Subject: **Mod 73**

Problem: **CPU does not retain the Site Specific Information**

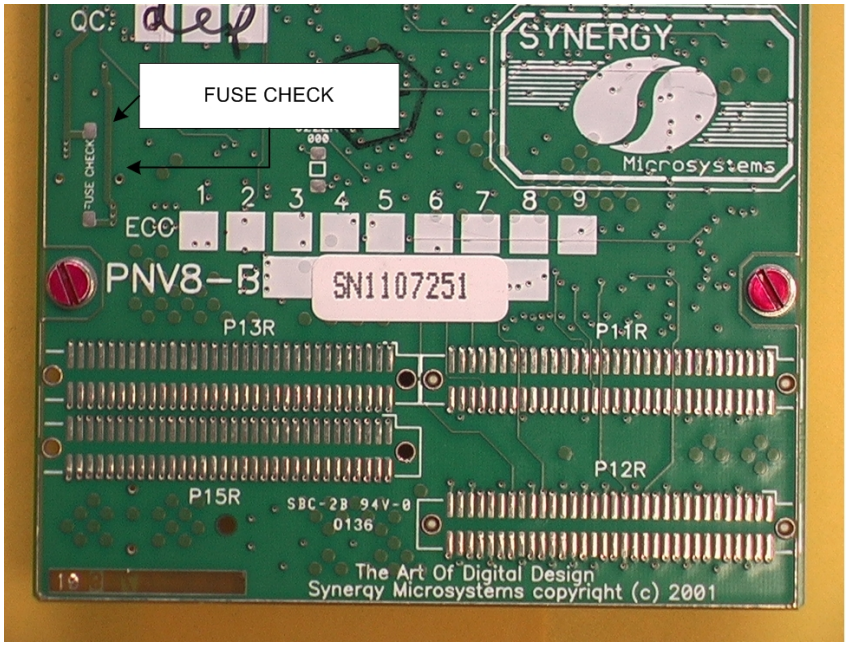
Solution: The new CPUs are shipped to the field with the battery backup disabled. The reason is to preserve the battery life while the boards are not installed in a system. This is accomplished by moving the fuse on the daughter board from the active position (FC31) to the spare position (FC32).

A fuse must be installed in the active position prior to installation. The fuse in the spare position can be moved to the active position or an additional spare fuse can be installed if one is supplied with the CPU packaging.

The fuse can be checked using an Ohm Meter by measuring between the “FUSE CHECK” test points on the back of the daughter board. This is easily accessible by laying the CPU track side down. The “Fuse Check” test points are located next to the daughter board part number stencil (PNV8-B) and a mounting screw closest to the CPU edge connector. The resistance should measure 1 ohm +/- 0.2.
